[Docket No. FAA-2005-22481; Directorate Identifier 2004-NM-176-AD; Amendment 39-14647; AD 2006-12-21]

Airworthiness Directives; Bombardier Model CL-600-2B19 (Regional Jet Series 100 & 440) Airplanes

ACTION: Final rule.

2006-12-21 Bombardier, Inc. (Formerly Canadair): Amendment 39-14647. Docket No. FAA-2005-22481; Directorate Identifier 2004-NM-176-AD.

Figure 2. Outboard Flap Go/No-Go Criteria in Take-off Position"

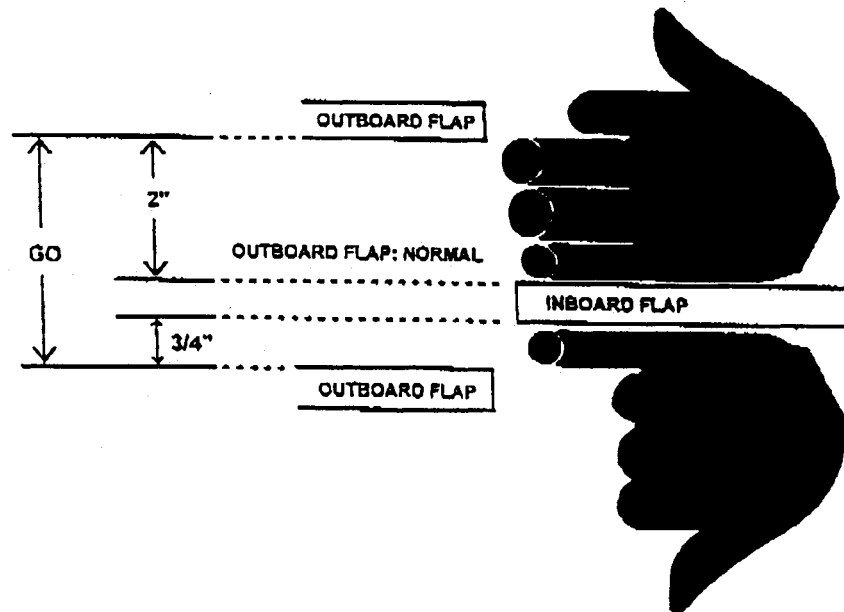
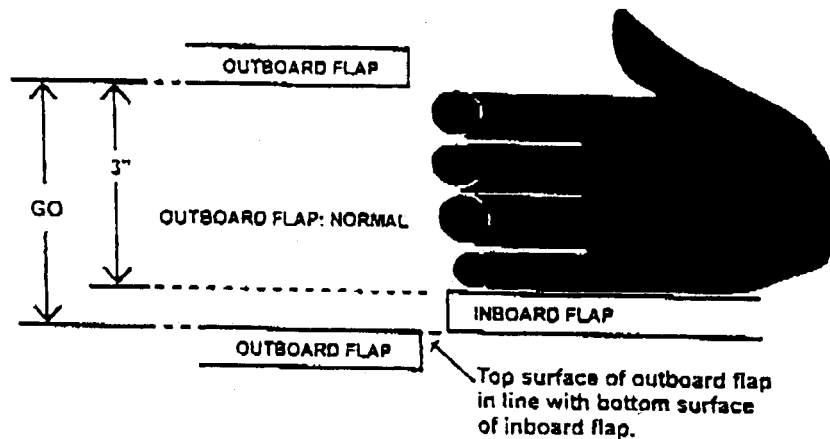
Important: If the outboard flap position is outside the “GO” range, as shown in figure 2., further flight is prohibited until required maintenance actions have been accomplished.

Note 1: If the outboard flap position is outside the “GO” range as shown in figure 2., further flight is prohibited until required

Whenever the outboard flap position indicator is outside the "GO" range as shown in Figure 2, or whenever directed to do so by the Maintenance Procedure above, perform the following procedures:
